Staff Report to the Zoning Administrator

Application Number: **08-0224**

Project Description: Proposal to construct a two story single family residence (about 5,547 square feet) with associated site improvements (including a shared roadway, with retaining walls up to 4.5 feet above and 8 feet below the roadway) and to remove one significant tree on a vacant property.

SITE PLAN
SCALE: 1" = 16'

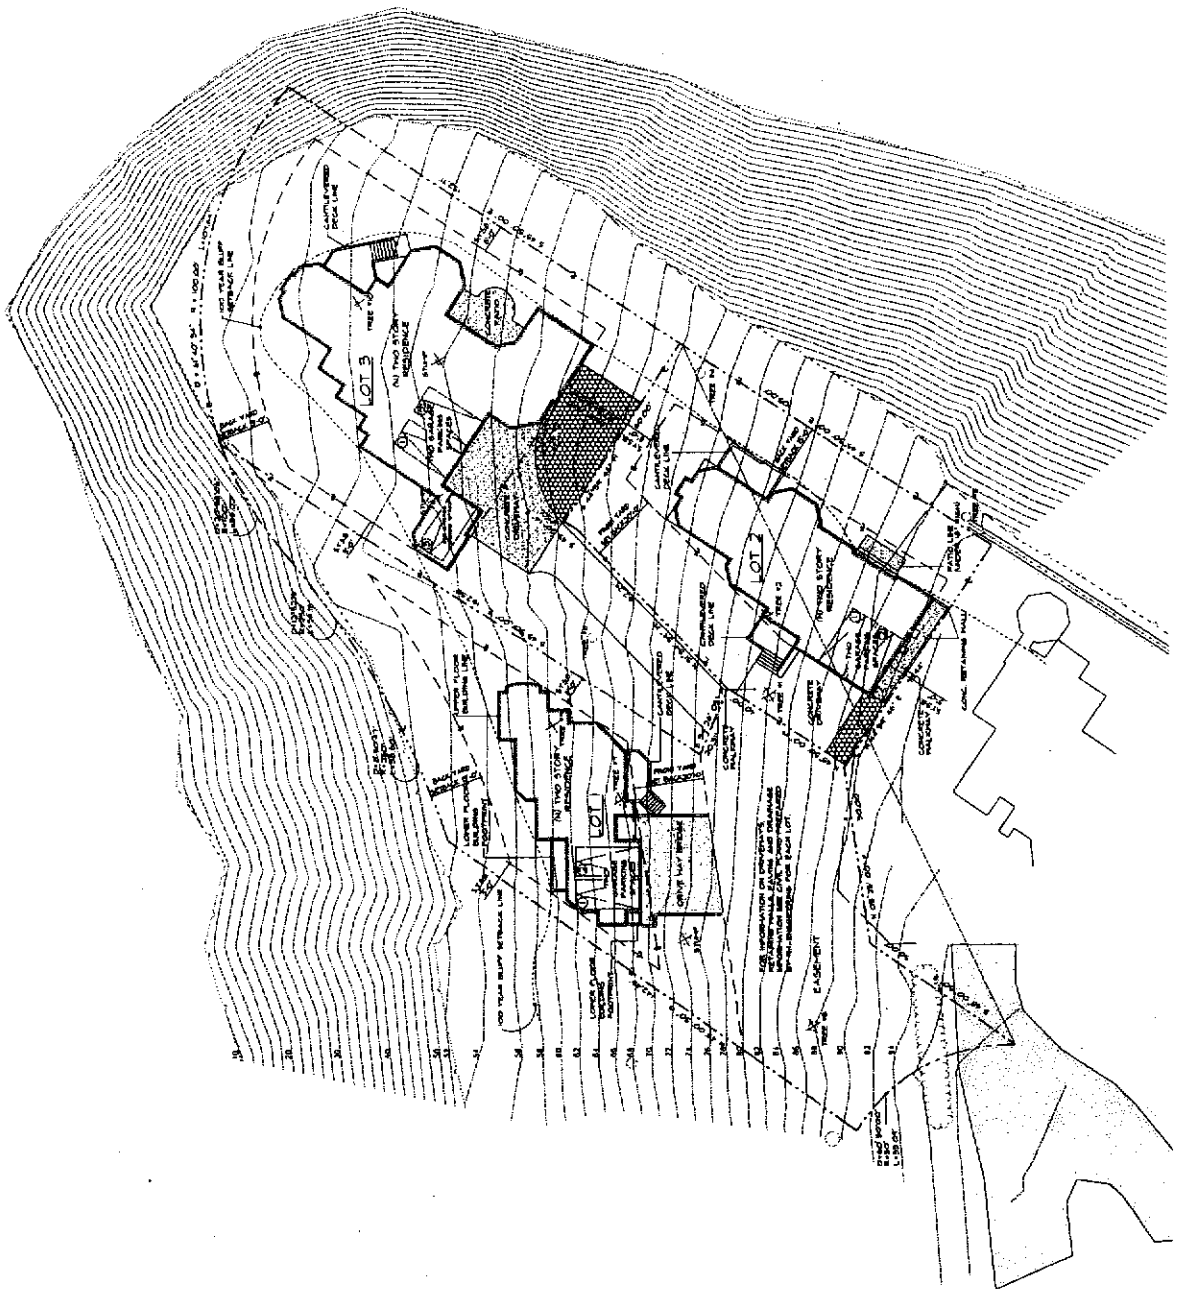
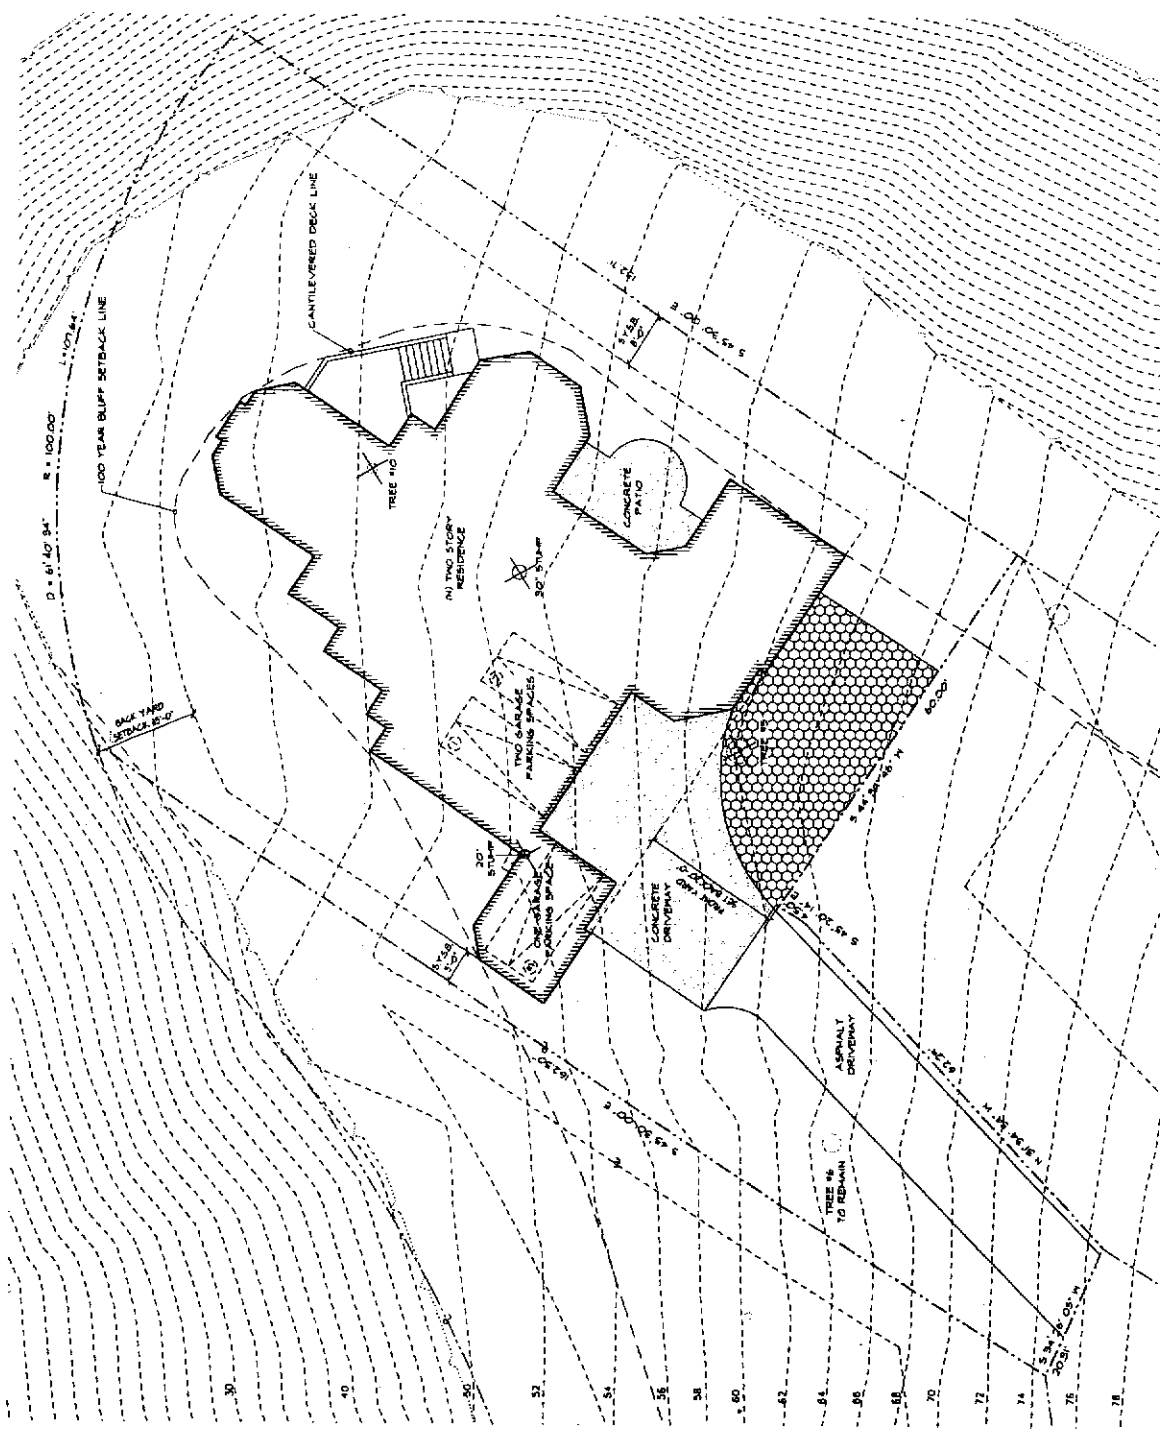
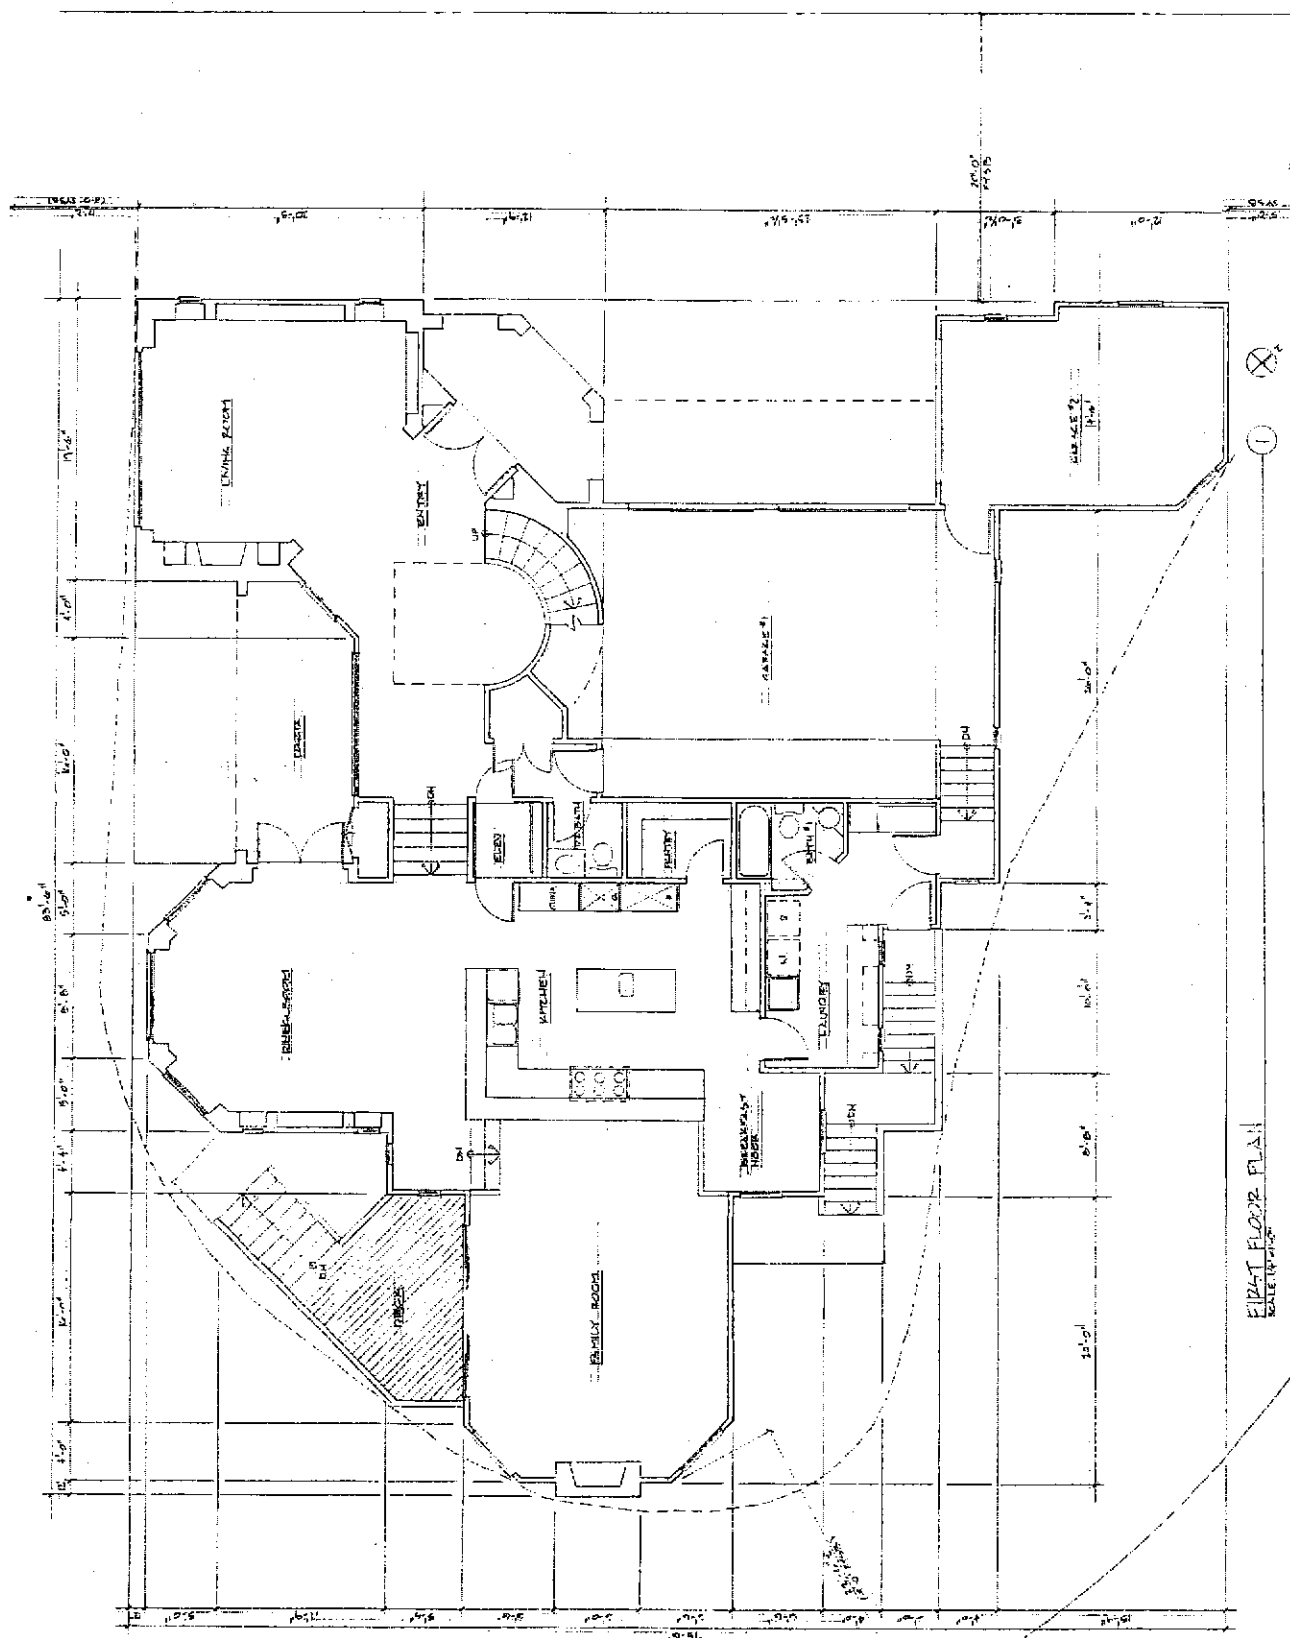
The proposed parking and circulation design lacks necessary backing and turning area for the proposed single car garage. It will be difficult for vehicles to back out and turn when exiting the parking space within the single car garage. The single car garage is recommended for removal to address this issue and to reduce the overall footprint and visual bulk of the proposed structure. Additionally, it is assumed that the sand paver area will be used as backing and turning area for the two car garage and to provide additional parking on the project site. The combined concrete apron and sand paver area may not exceed 50 percent of the required front yard area. The architectural site plans indicate a larger combined area (over 50 percent of the required front yard), where the civil drawings indicate a smaller area in compliance with required site standards.

- 3. The parking and circulation area (concrete and sand paver area combined) shall be revised and shall not exceed 50 percent of the required front yard setback (the area of the 20 feet front yard setback as measured from the minimum lot width, not including the access corridor portion of the parcel).

2-14-41.3078
NORTH ELEVATION

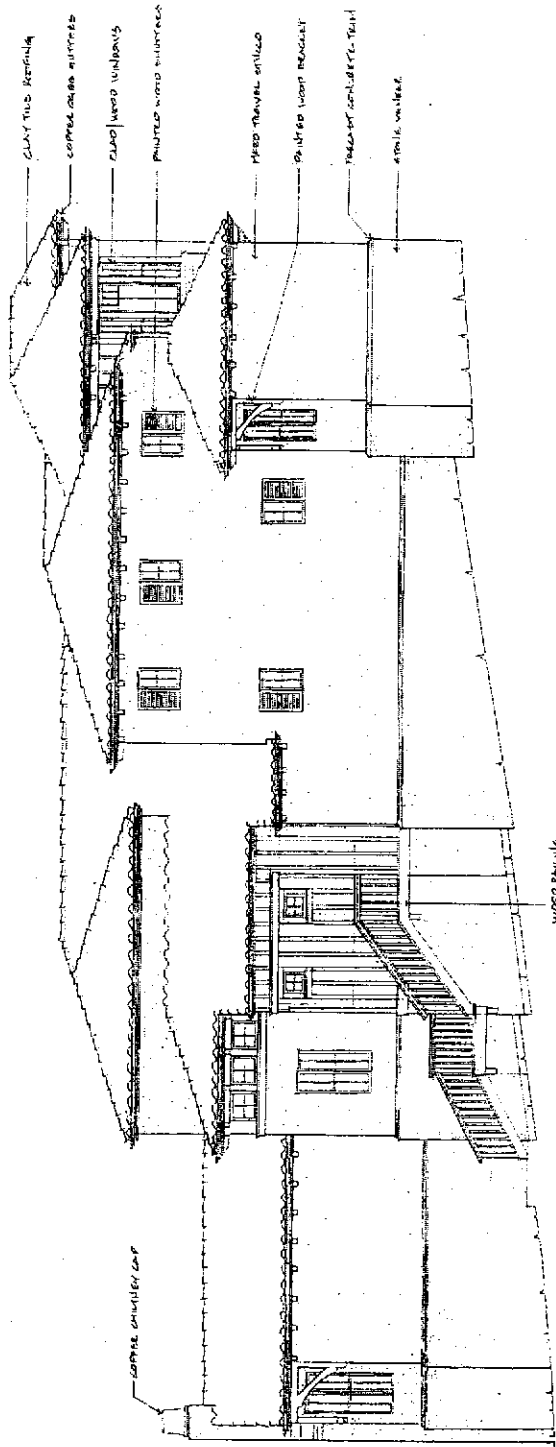
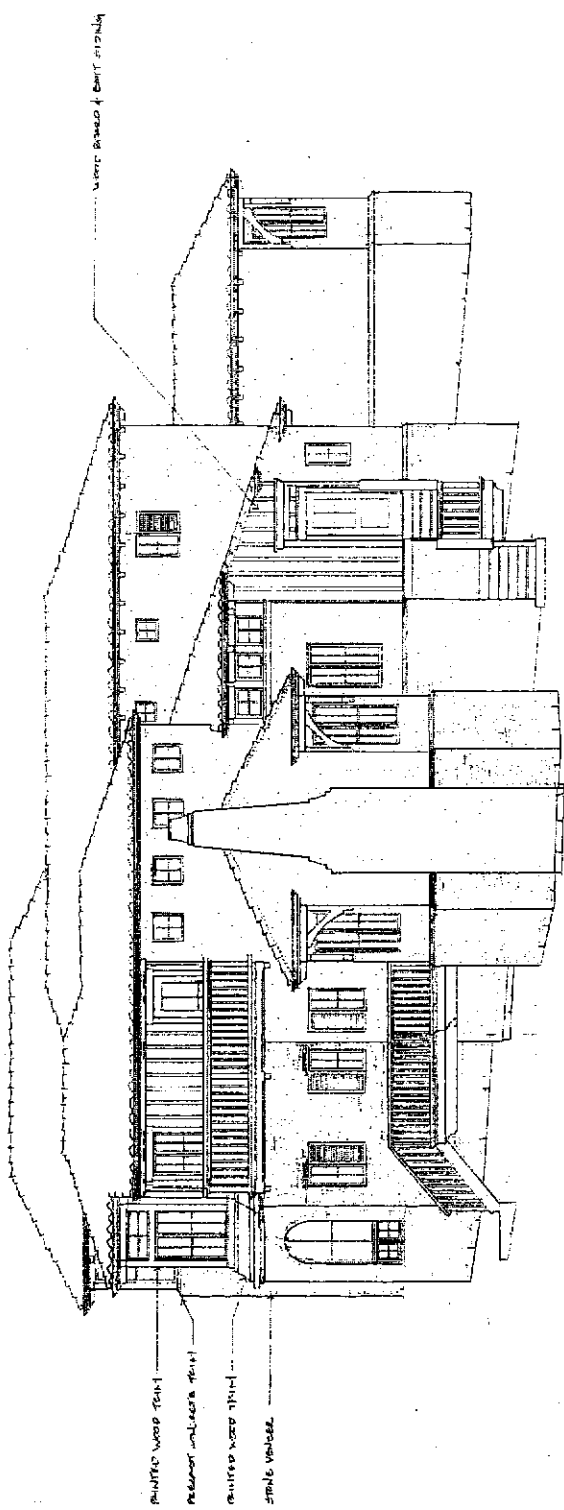
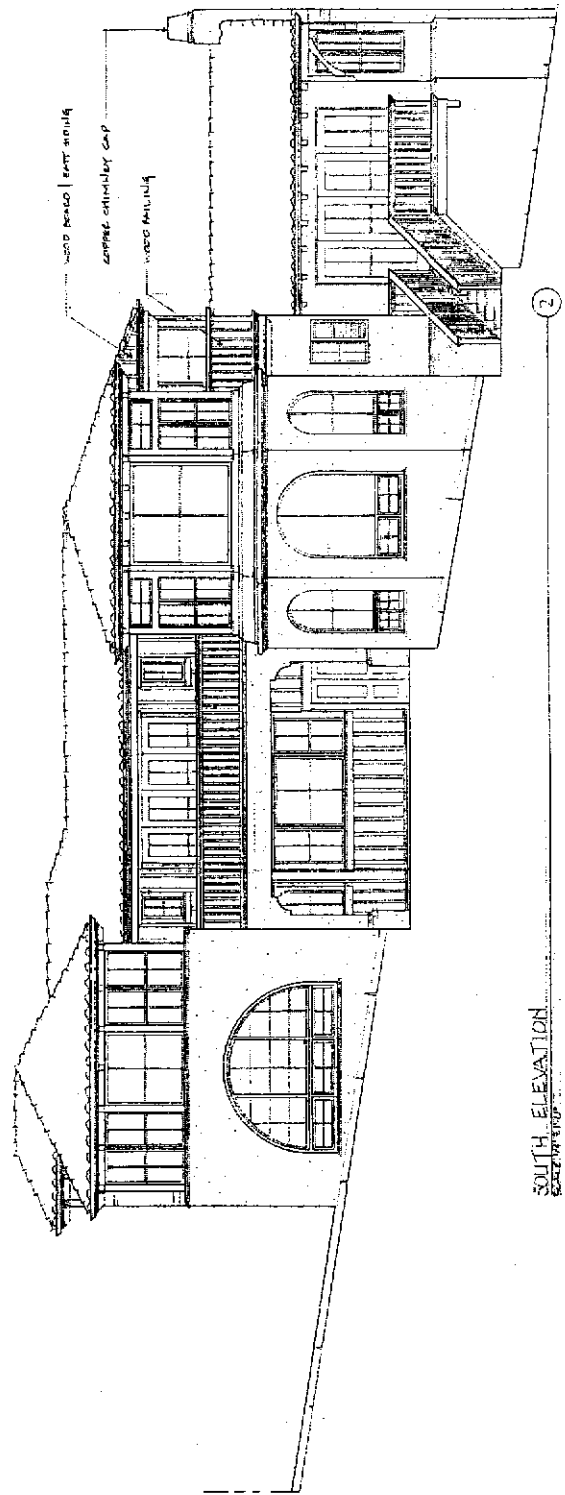
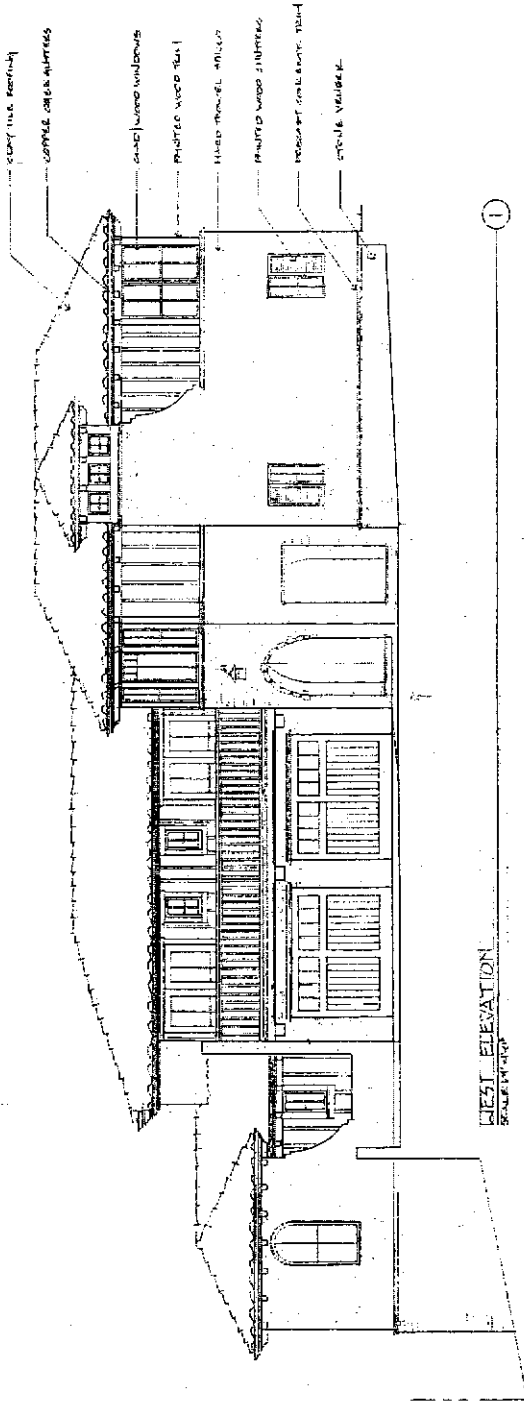
The current color proposed for Lot 3 is a burnt orange, which may be too bold to allow the structure to recede into the background. Color modifications are recommended to reduce the visual bulk the residence. This includes using the color from Lot 1 on Lot 3 (which would place the olive green body color for the larger residence) and by modifying the colors of the other materials towards grey, tan, or light brown to reduce the visual bulk of the structure. With an appropriate mix of colors and materials for each residence, the apparent bulk and mass of all three residences could be further reduced.

- 2. The architectural plans shall be revised as follows:
 - a. The single car garage shall be removed and appropriate finish materials shall be added to the north elevation to break up the two story stucco wall mass.

- a. The body color for the residence on Lot 3 shall be modified to be a light green or olive color. The color selection shall be balanced with the colors of the other residences to provide variety and to allow the structure to recede into the background.
